Re: **Addendums and Dividers for Approved Work Plan dated 28 July 2000**  
**Project No. 805169**

### Work Plan – Removal of Asbestos and Vermiculite at the Libby Asbestos Site

**ADDENDUM NO. 2**  
**Work Plan – Removal of Asbestos and Vermiculite**  
**at the Export Plant, Libby Asbestos Site**  
**28 July 2000**

**ADDENDUM NO. 6**  
**Work Plan - Removal of Asbestos and Vermiculite**  
**at the Export Plant, Libby Asbestos Site**  
**06 September 2000**

# FIGURE 1 REDUCED EXCLUSION ZONE-EXPORT PLANT

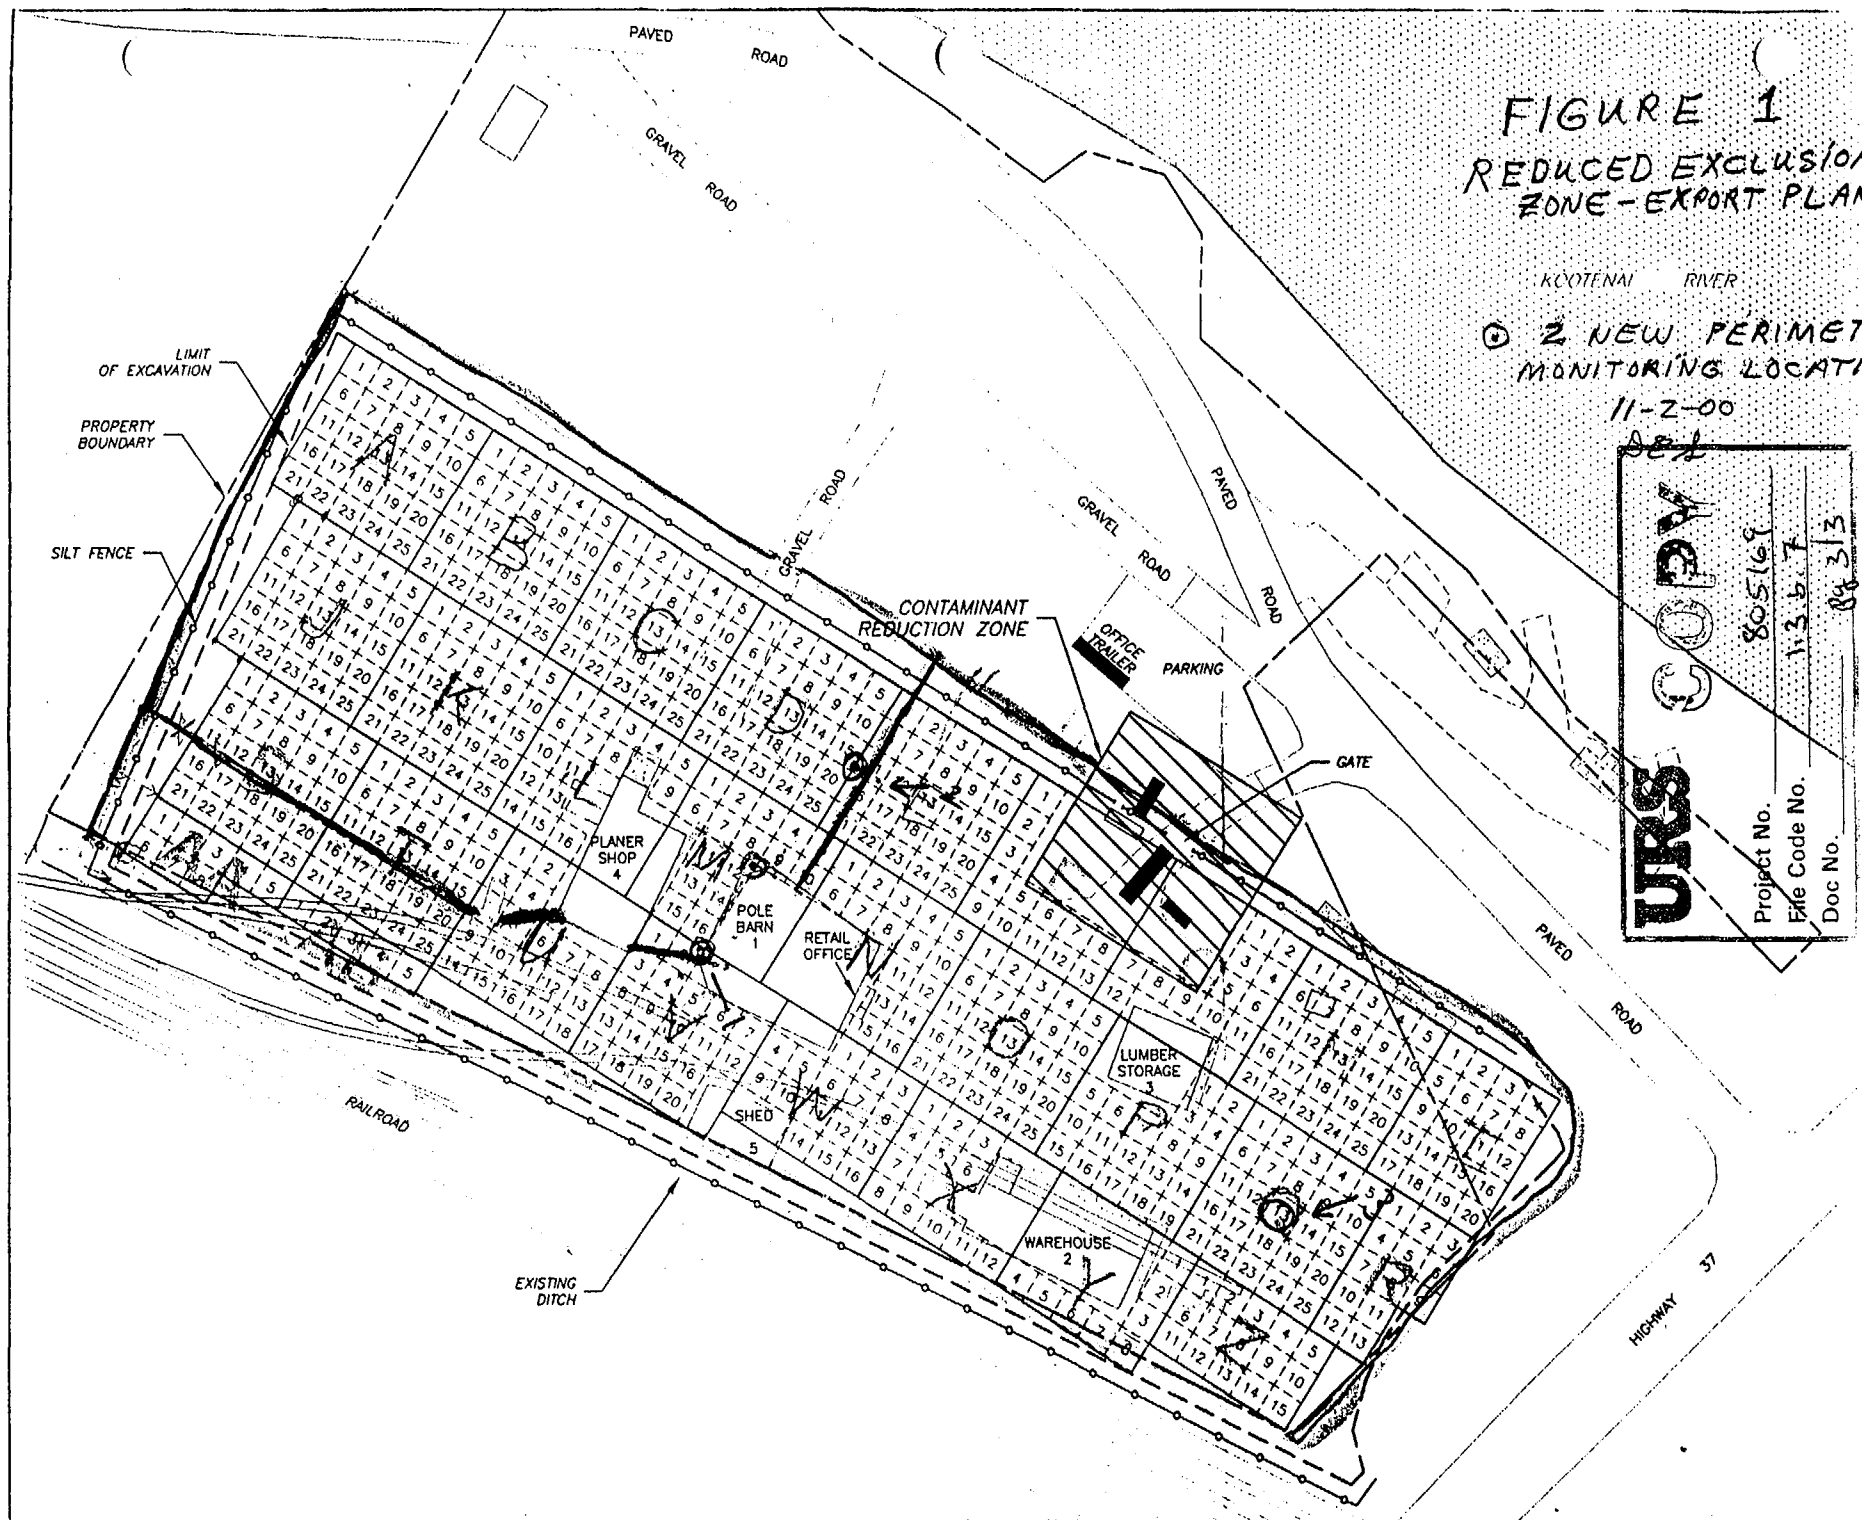
This addendum to the 28 July 2000 Work Plan for the removal of asbestos and vermiculite at the Libby Asbestos Site is issued to reduce the size of the current Exclusion Zone (see Figure 1 attached). The reduced size of the exclusion zone will allow Millwork West to operate in the Planer Building by November 13, 2000. URS will have perimeter air monitoring samples taken daily at three locations (see Figure 1 attached) along the new west boundary of the Exclusion Zone.

When the planer run begins, URS will excavate soils at the east end of the property. URS will reduce perimeter air monitoring along the new west boundary to one location when the planer run has been completed.
